# UNITED STATES PATENT AND TRADEMARK OFFICE

APPLICATION NO.	FILING DATE	FIRST NAMED INVENTOR	ATTORNEY DOCKET NO.	CONFIRMATION NO.
10/826,855	04/16/2004	Yang Li	HS-127	2084

**Office Action Summary**

Figure 3

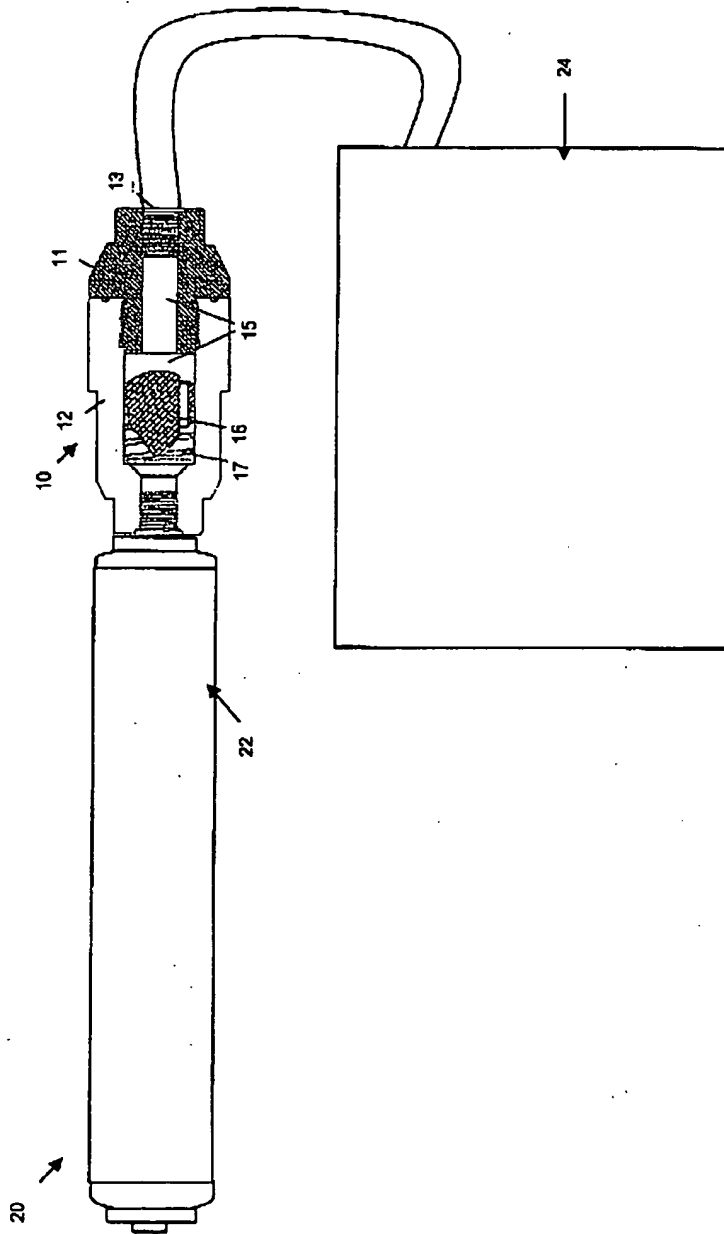
Approved.  
RK  
03/31/07
